APPENDIX G: NOISE PEER REVIEW

Noise Peer Review – Wilkinson Murray

Re: Noise/Vibration Assessment - Wilpinjong Extension Project - Independent Review

**RE: WILPINJONG EXTENSION PROJECT (SSD 6764) – NOISE PEER
REVIEW – STAGE 1**

APPENDIX A – Output of ENM noise model

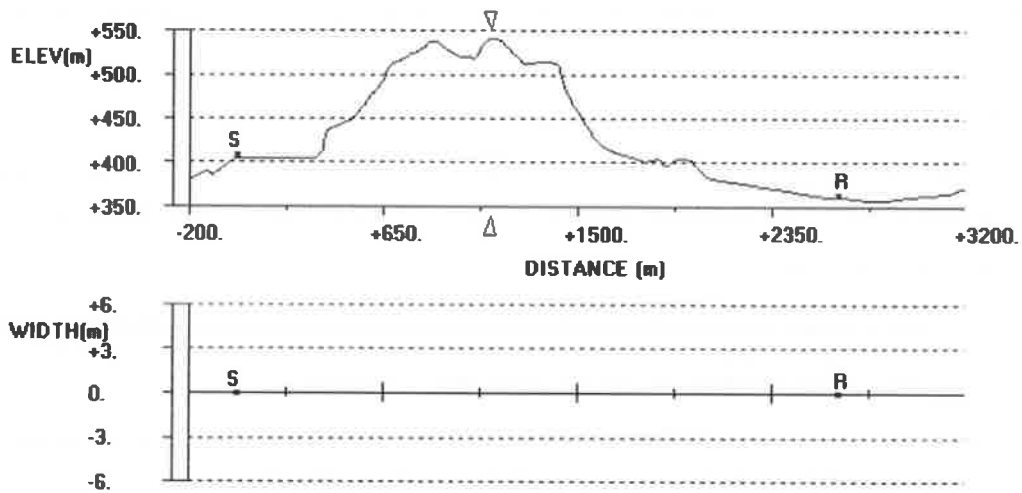
The output of the ENM noise model in the form of cross section between pit 8 and Wollar and noise attenuation is presented in Appendix A. WM considers the noise model to be very detailed and as accurate possible.

Low Frequency Noise Assessment of 2012 Noise Monitoring Data in
Accordance with the dING

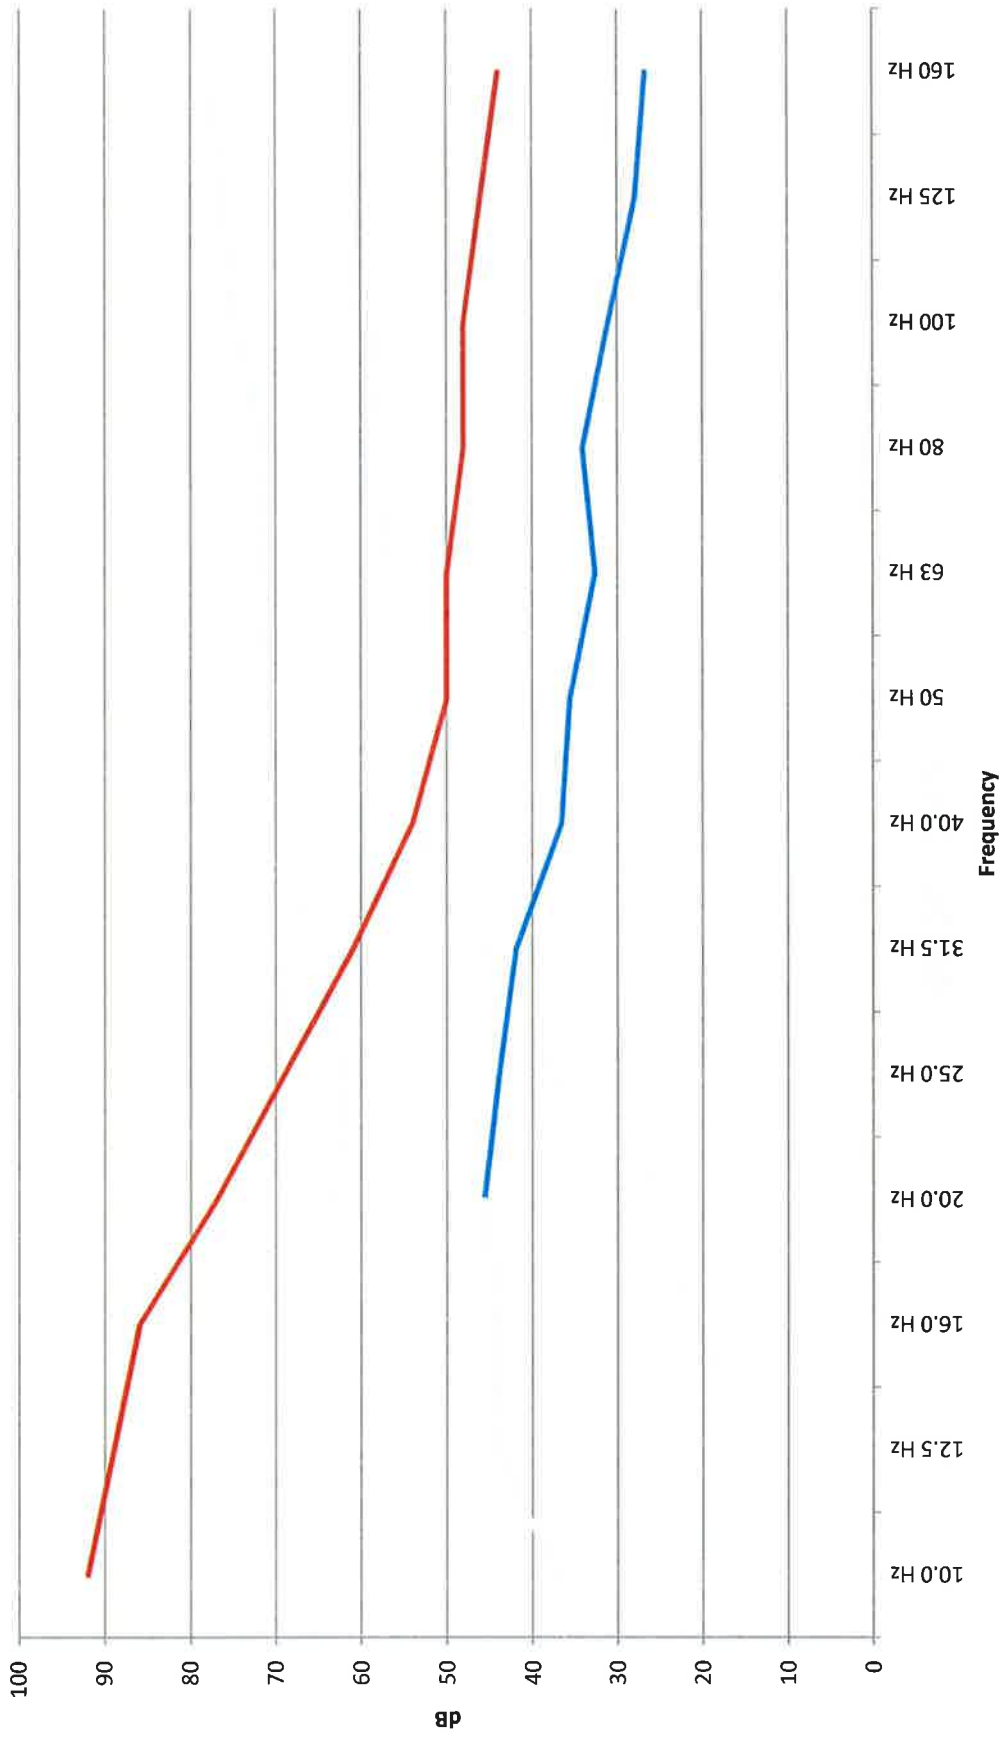
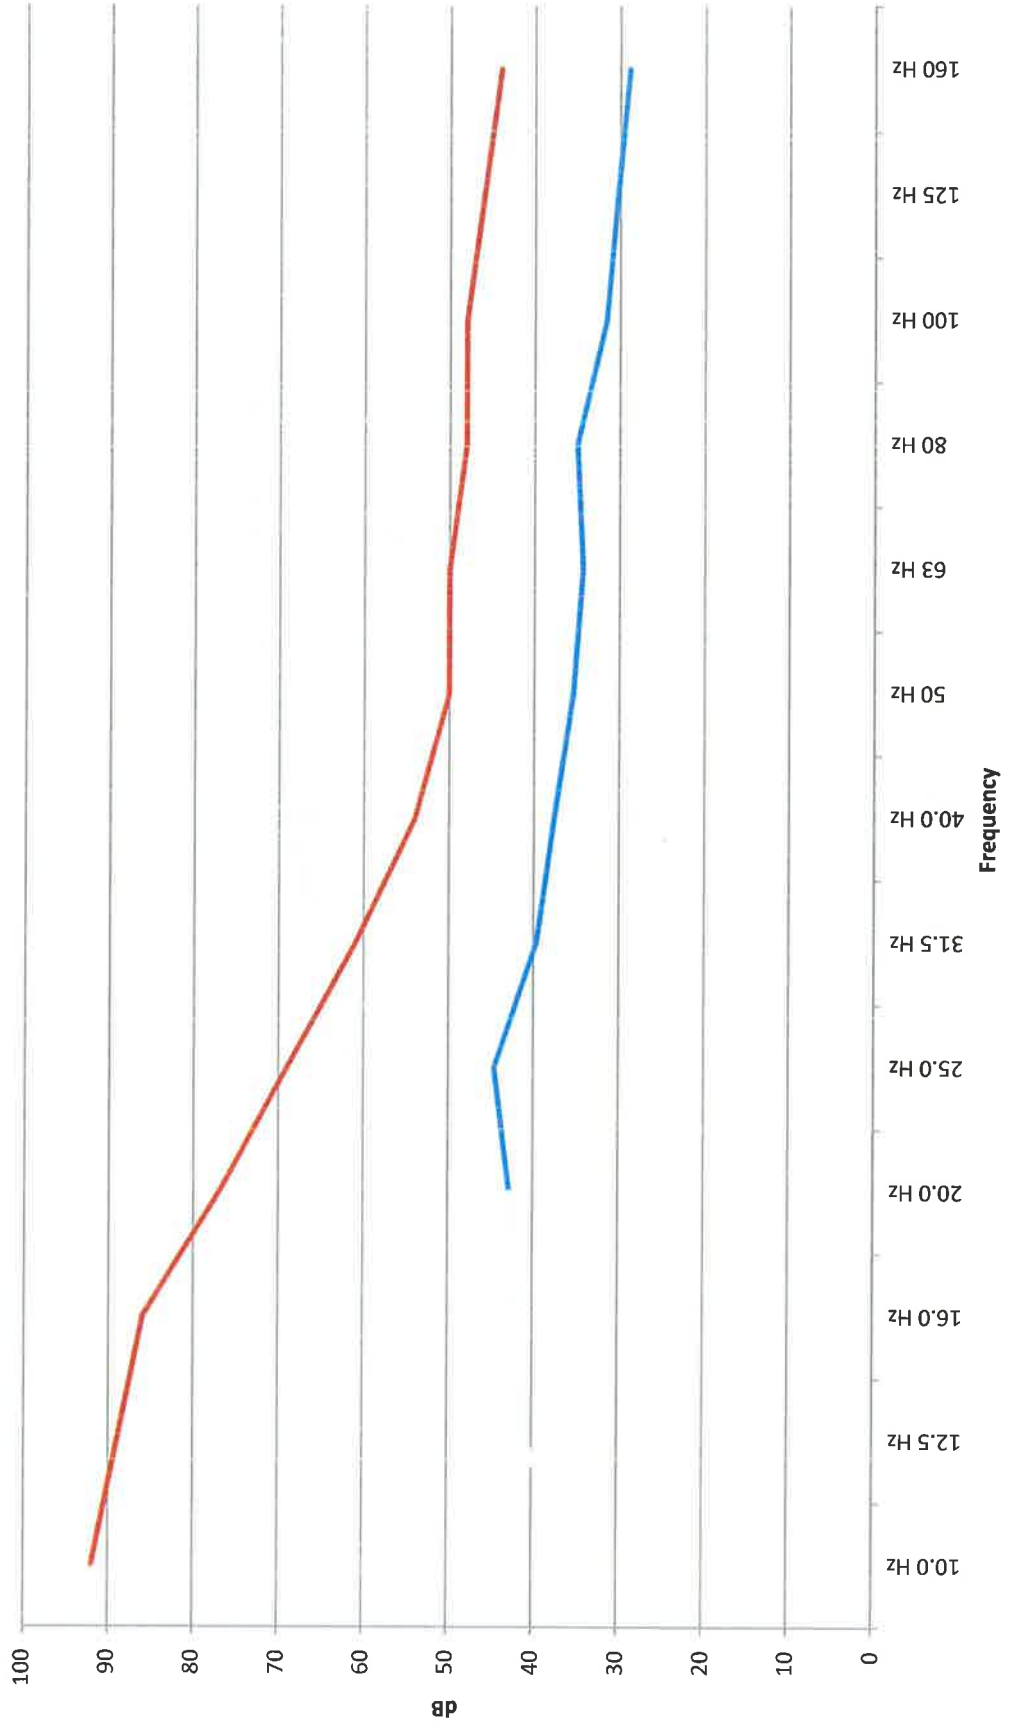
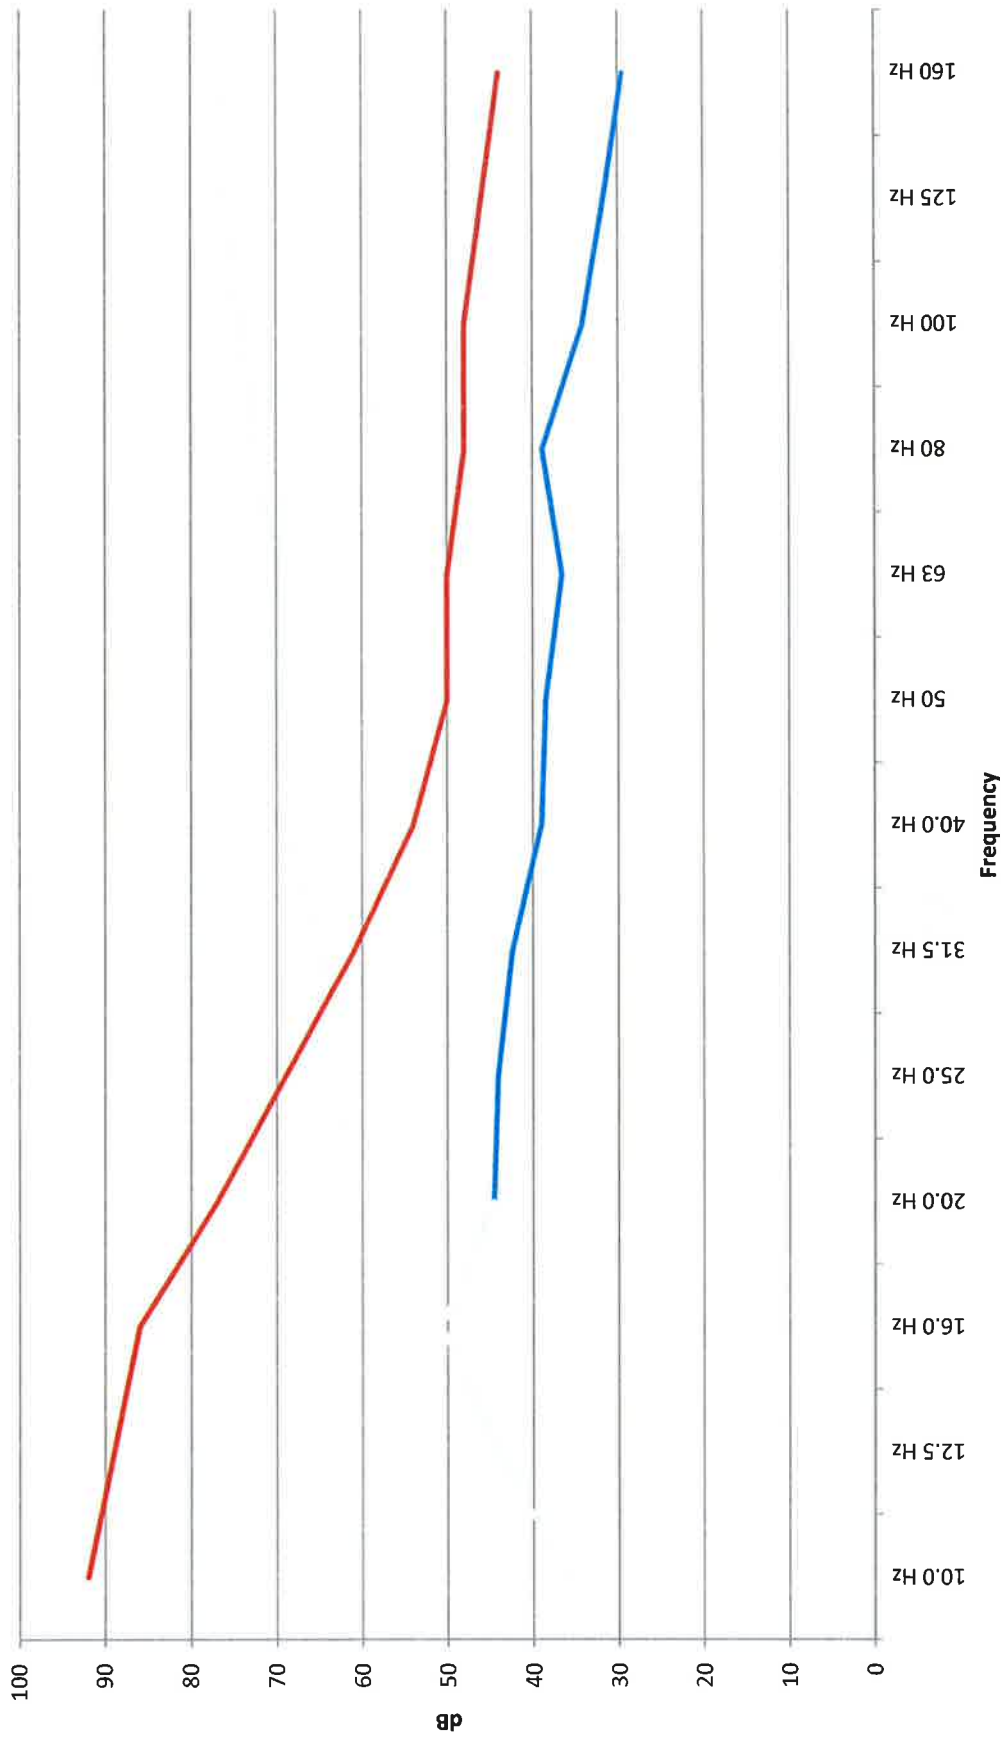
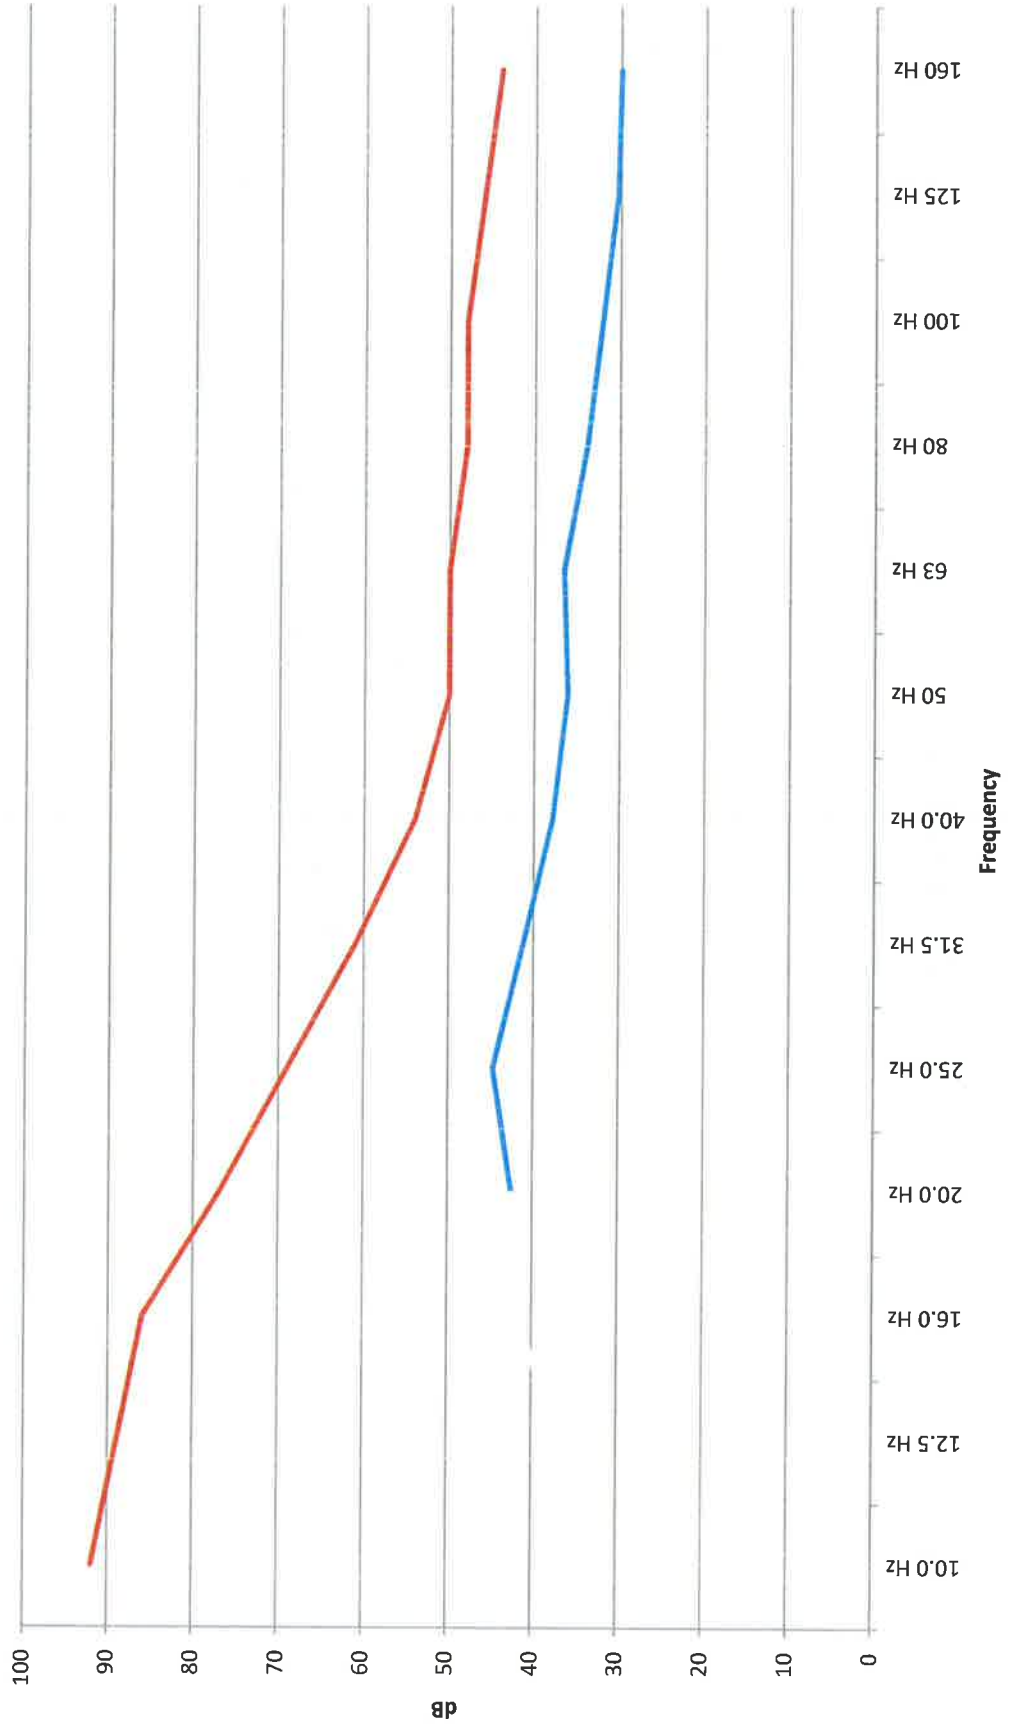
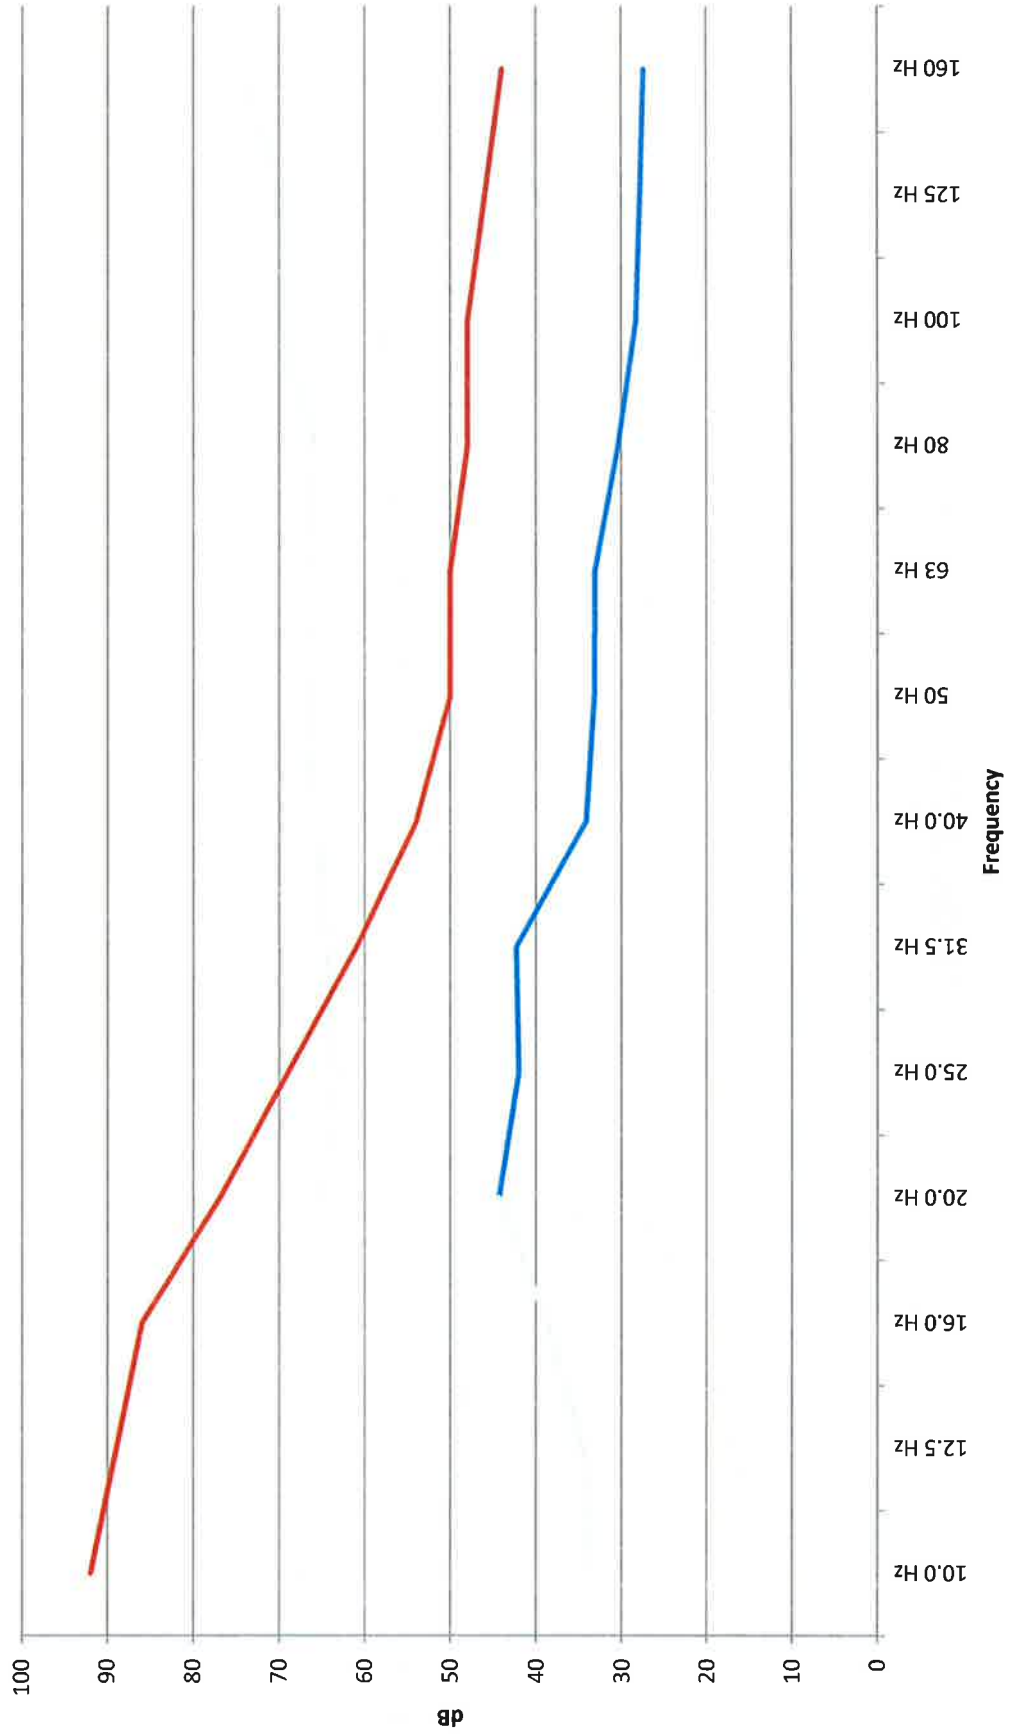
Also attached are graphical outputs of the measured Z weighted noise levels for comparison against the EPA's modified DEFRA criteria (Table C2 of the DING).

The same 147 15 minute individual measurements have been further analysed in accordance with Tables C1 and C2 of the DING. Some 146 (out of the 147) comply with Table C2 of the DING. One individual 15 minute measurement at 1am on 16 December 2012 exceeded the Table C2 1/3 octave band criterion of 46 dBZ (@ 125Hz) by a marginal 1.7 dB. However in this 15 minute period, the overall A weighted noise level was 37.0 dBA and the corresponding overall C weighted noise level was 50.9 dBC (i.e. a difference of 13.9 dB) and therefore this noise level is not assessable for LFN in accordance with Table C1 of the DING.

SLR Consulting conducted an analysis of low frequency noise using the methodology presented in the draft Industrial Noise Guideline. The analysis supported their EIS conclusion that the noise generated by the Wilpinjong Coal Mine does not contain dominant low frequency noise content. Wilkinson Murray concurs with this conclusion.
